PLANNING AND DEVELOPMENT SERVICES STAFF REPORT

For Planning Commission Meeting of February 21, 2018

SUBJECT: 2900 Huron Parkway Landscape Modification Request (2900 Huron Parkway) File No. SP17-037

DRAWING NUMBER **LP-001**

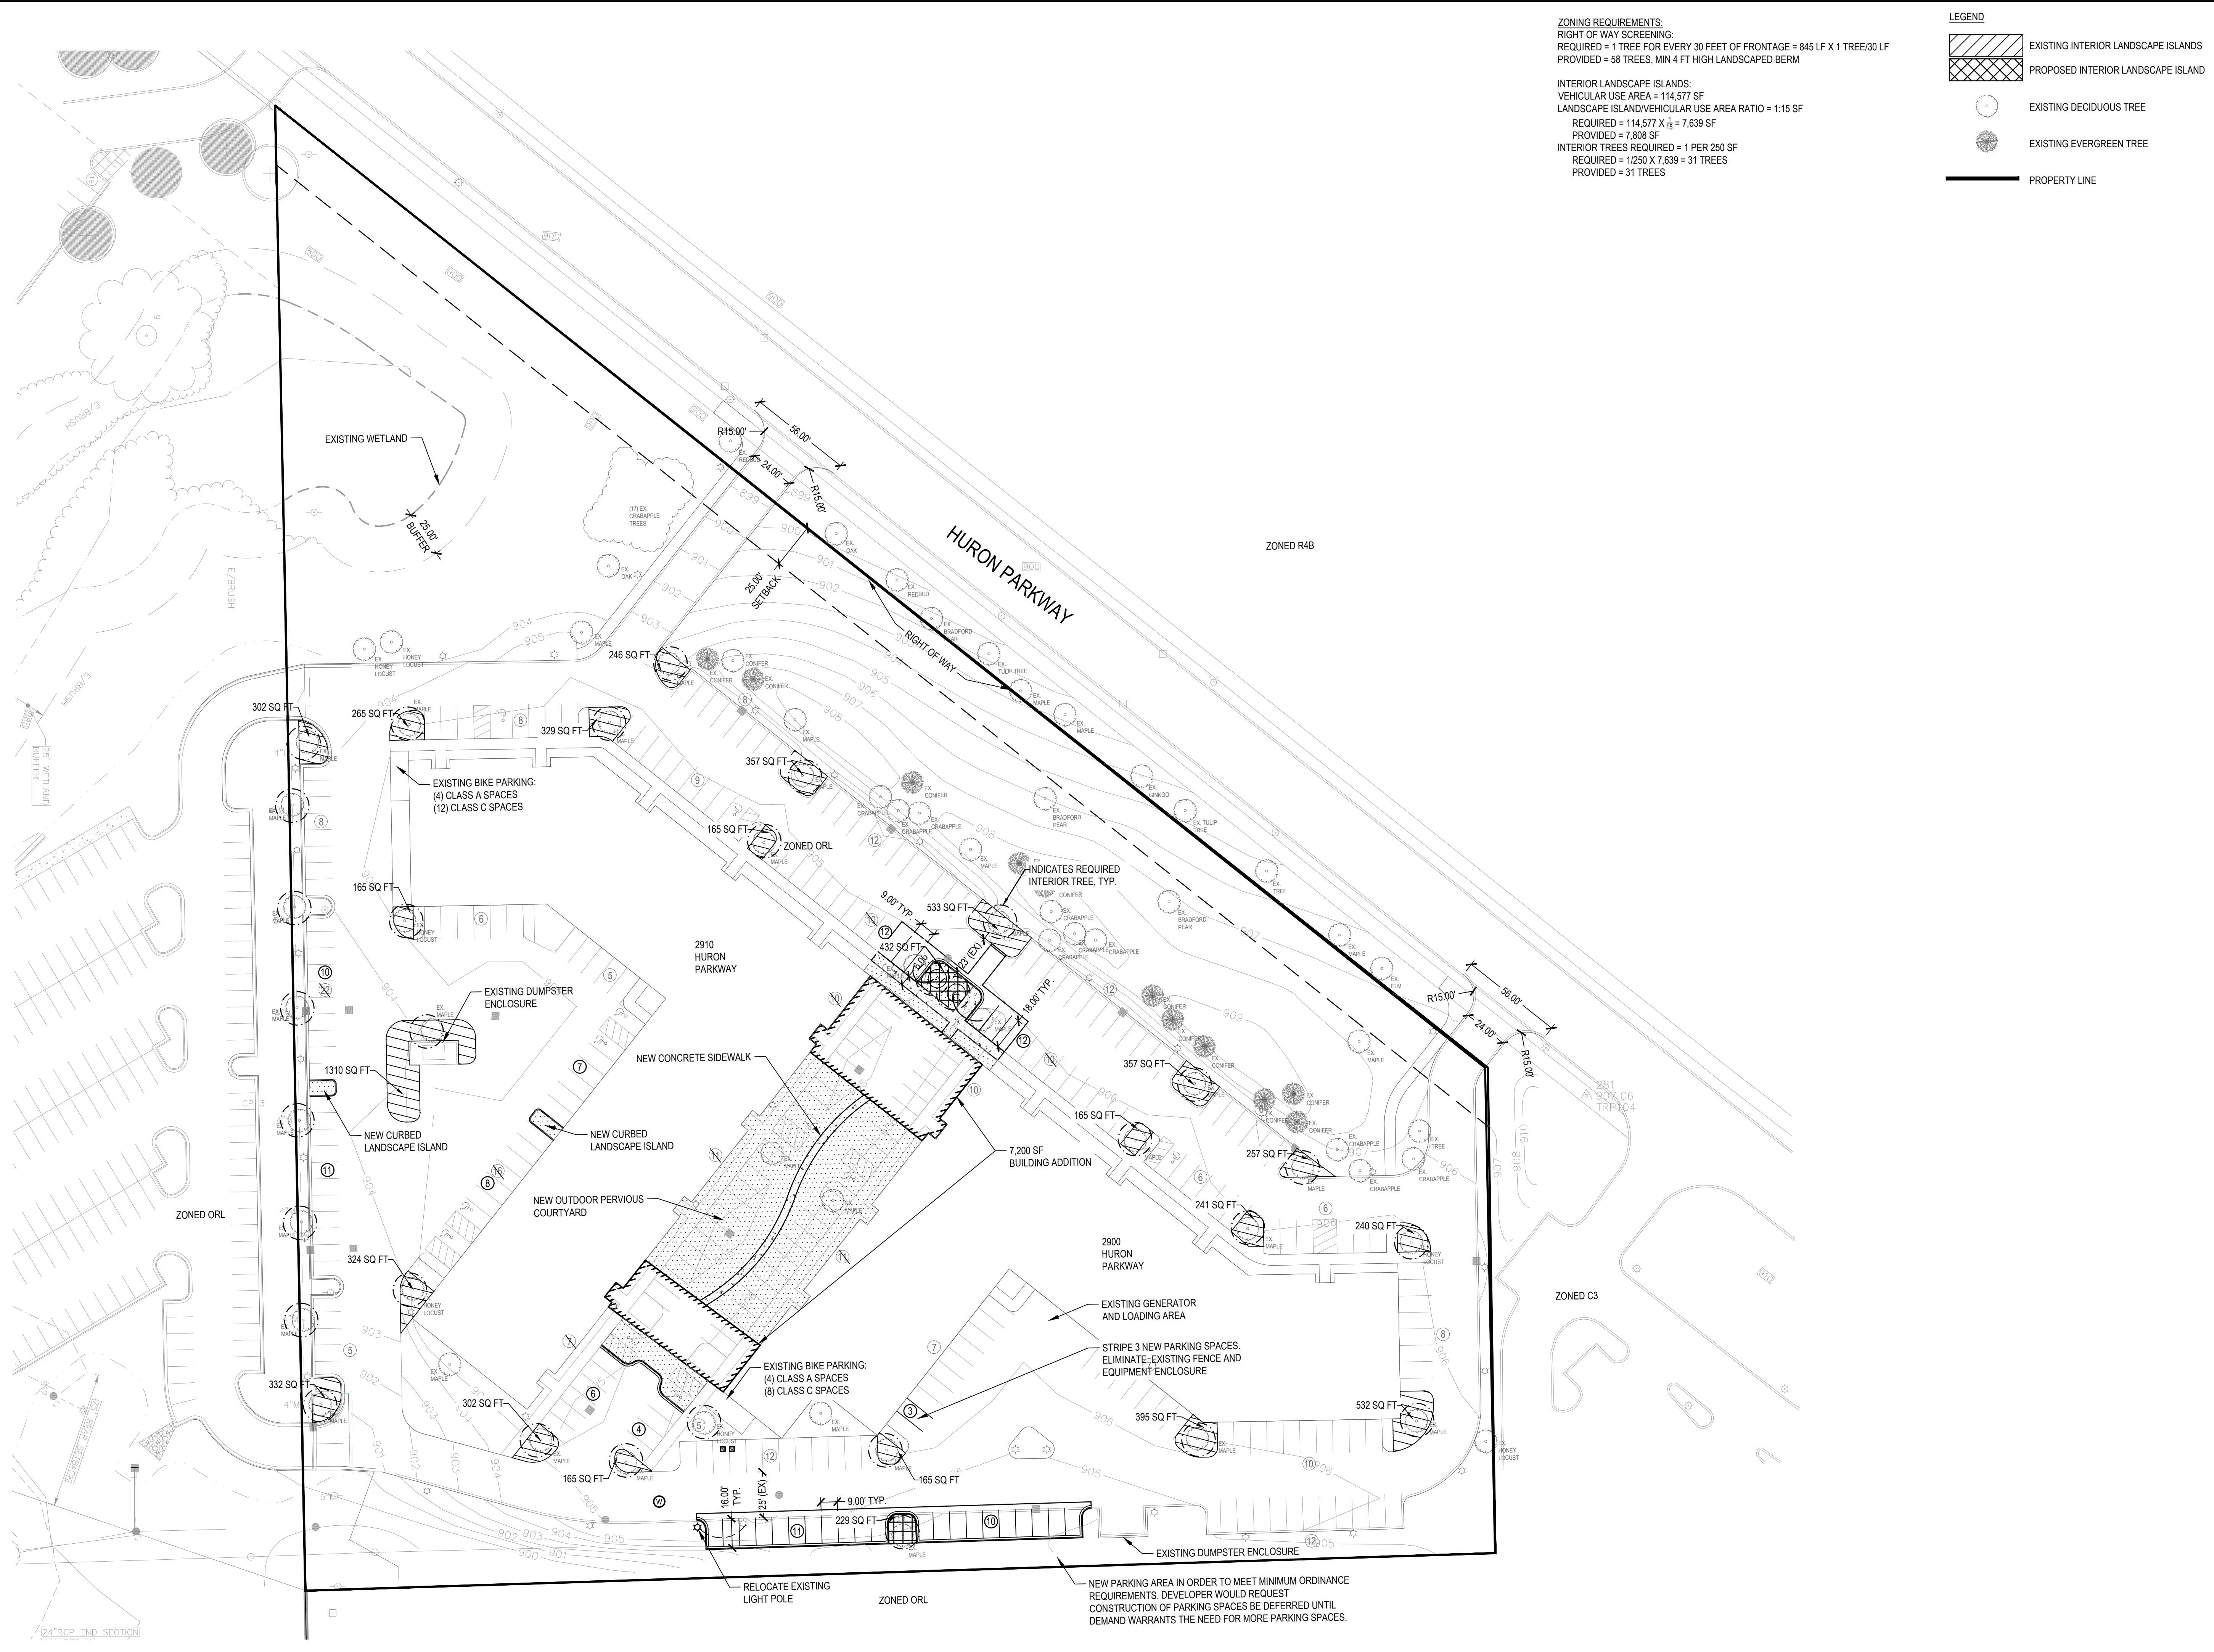
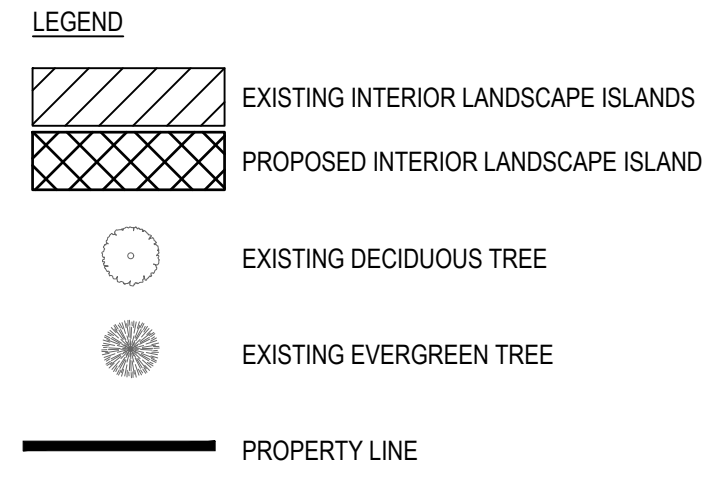
The petitioner is asking for a modification from the section of Chapter 62 (Landscaping and Screening) that requires new landscaped islands and bioswales be constructed in existing parking lots. The petitioner has indicated that no changes are proposed in the remaining parking areas and that there is not sufficient space in the areas immediately adjacent to the parking lot to install bioretention areas without regrading a majority of the parking lot and removing existing interior landscaping island trees.

- When the total area required in interior landscape islands for all of the vehicular use areas on site exceeds 750 square feet, at least 50% of the area in the required interior landscape area must be depressed bioretention areas and utilized for storm water management. Depressed bioretention areas can be used to meet the stormwater pretreatment requirements in Chapter 62.

Staff recommends that this landscape modification be **approved** because the modifications are consistent with the intent of the ordinance and are associated with a previously approved site plan.
